Lesson to be learned in public presentations

General Description of Plant Fill Problem and Its Extent

List of Vu-graphs for ACRS Presentation - Geotechnical Engineering

CONSUMERS POWER COMPANY MIDLAND UNITS 1 AND 2
GENERAL LAYOUT OF SURCHARGE LOAD DIESEL GENERATOR BUILDING
FIGURE I-1 GES-58

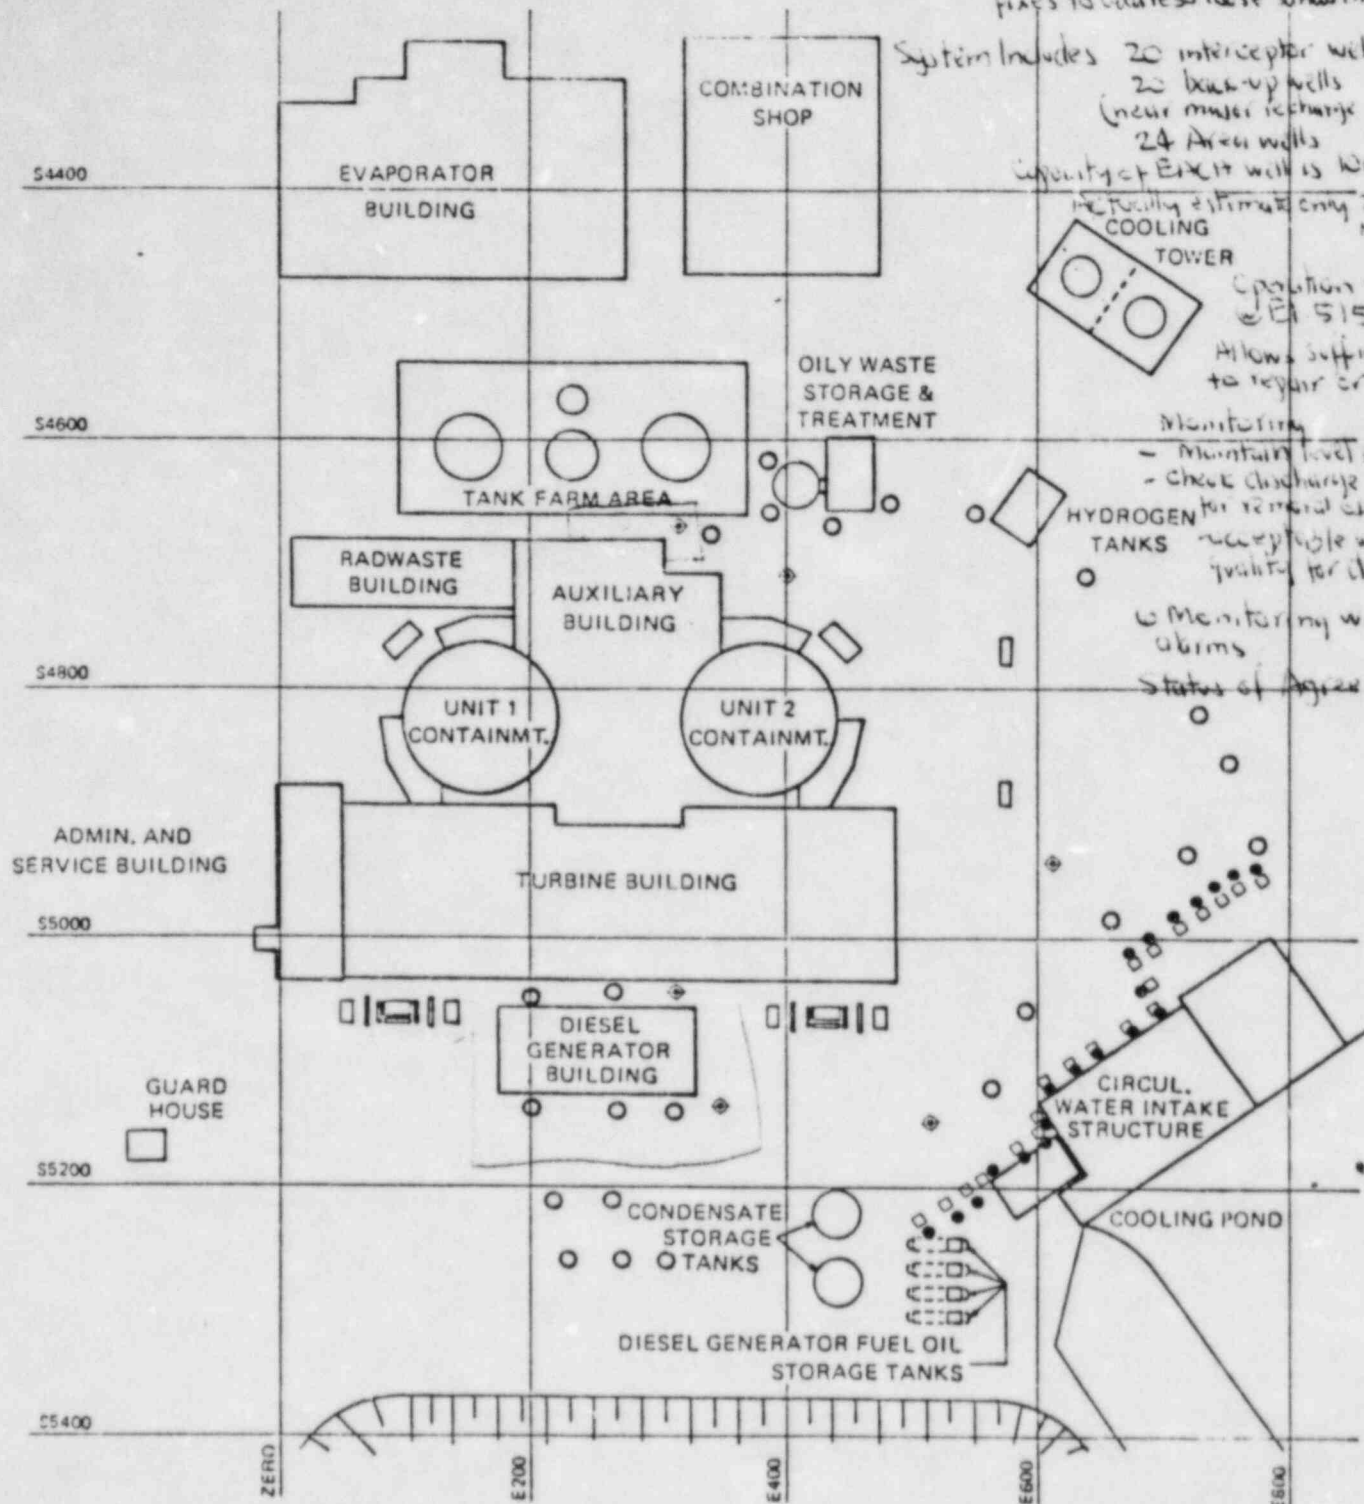
Show plan and sectional view of surcharged DGB area. The DGB is supported on continuous wall footings founded @ El. 628 (Approximately 25' to 30' of plant fill beneath structure). The plant fill is heterogeneous and consists of cohesive soils and granular soils, to a greater extent on the north side.

In July 1978, with the building about 60% complete, the settlements recorded indicated values greater than what had been anticipated for the entire plant life. Investigations showed the plant fill was settling under its own weight.

Describe surcharging (Placement of 20' of sand inside cut, etc)
~~So~~ Full 20' height of surcharge was held for about 4 1/2 months and then removed

We could spend the rest of the day discussing the Applicant's and the Staff's ~~positions on the~~ differences on evaluating the effectiveness of the surcharge program. The bottom line is, however, that we have reached agreement on the total and differential settlements which should be used in the structural analysis that evaluates the stresses induced by settlement. The Applicant is currently analyzing the stresses induced by settlements which occurred before and during surcharge. We are hopeful the results of these analysis will permit final resolution to be reached on the acceptability of the completed surcharge program.

About 60% completed when problem discovered in July 1978

GES-60

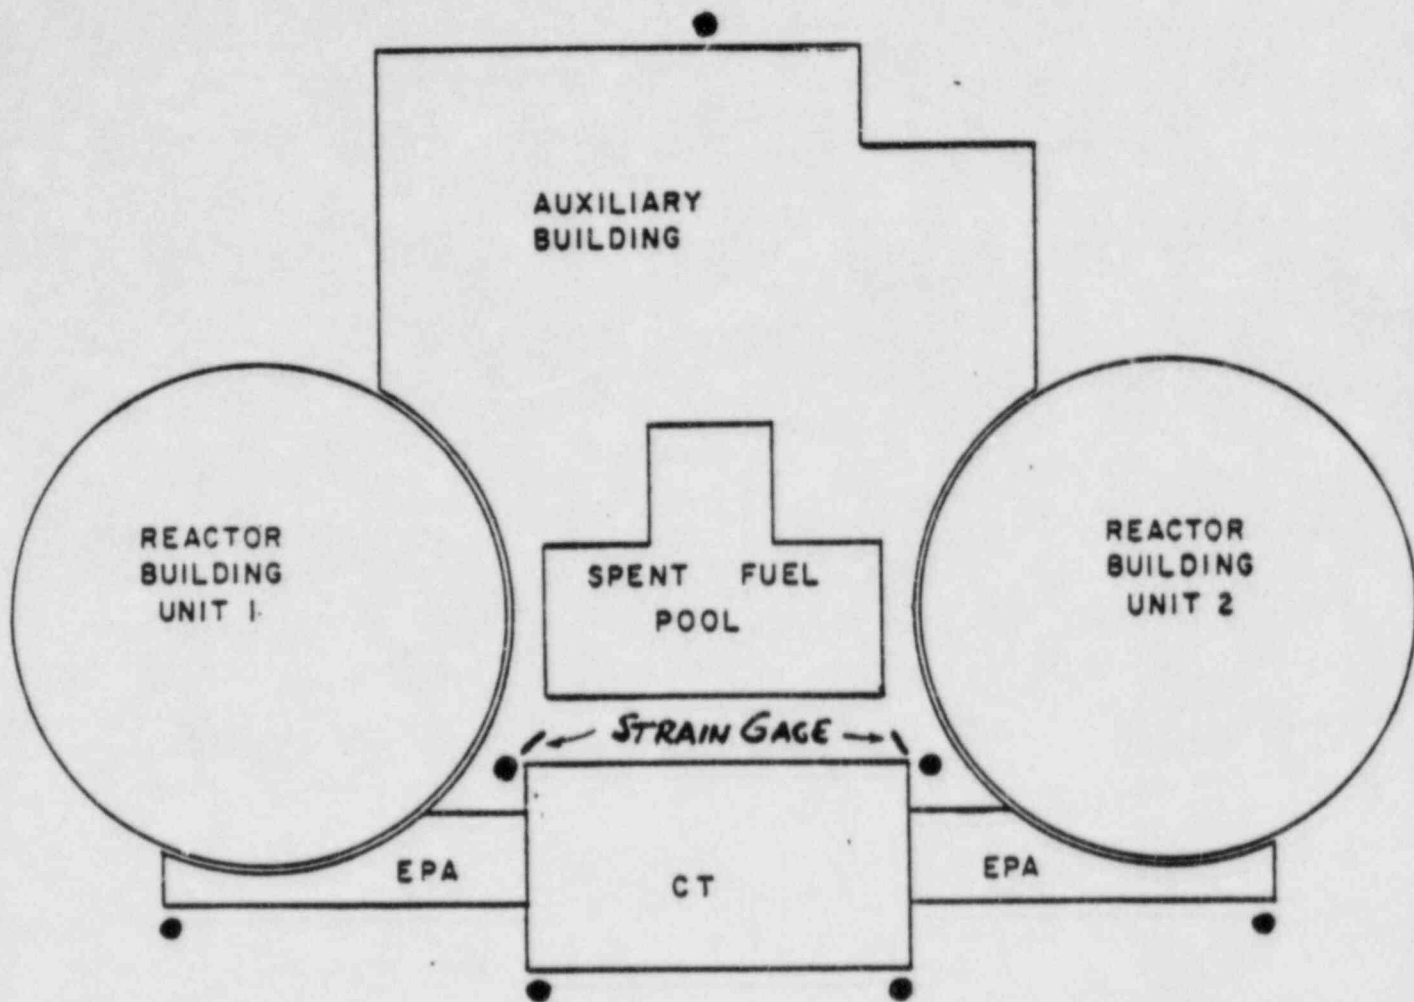
Permanent dewatering system is necessary because of potentially liquefiable loose sands in plant fill (above El. 610) in areas of DGB and RR Bay area. ^{Foundation problems with} Loose sand backfill at other locations (SWs, EPA, underground piping) have been remedied with other fixes

- Maintain groundwater @ El. 575 during plant operation in DGB & RR Bay areas

This permits sufficient time, in the event of system failure, to either repair system or shut plant down before groundwater level reaches El 610 - the lower level where liquefaction is a concern

Necessary - Potentially liquefiable loose sands on plant floor
 - Other locations (EPA, SWS, piping) have plans to address loose sands in those areas

System Includes 20 Interceptor wells
 20 back-up wells (near major recharge source)
 24 Area wells
 Capacity of EXCIT well is 10gpm
 Accuracy estimate only 22 wells NEEDED

Operation - Maintain @ El 515
 Allows sufficient time to repair or shut down.

Monitoring - Maintain level @ El. 515
 - Check discharge water for removal of fines
 - acceptable water quality for discharge

Monitoring wells w/ alarms
 Status of Agreement

3 - The Staff concurs with the Applicant that the two plant areas which require operation of the permanent dewatering system are the DGB area and Railroad Bay area, ^{as} ~~shown~~ on Fig. 4-1.

The Staff agrees that maintaining the GWL below El. 610 in the DGB and Railroad Bay areas will assure plant safety against liquefaction type failure.

HES The Staff agrees that the 40 interceptor wells and 24 area wells are sufficient, with adequate redundancy, to maintain the water levels in the vicinity of the DGB and Railroad Bay area below elevation 610. (Based on analysis and drawdown test results)

HES The Staff concludes that in the event of a complete failure of the ^{permanent} dewatering system there would be at least 60 days before water levels would rise to elevation 610. beneath the DGB. Based on results of the recharge test we know the time would be greater than 60 days for the Railroad Bay area.
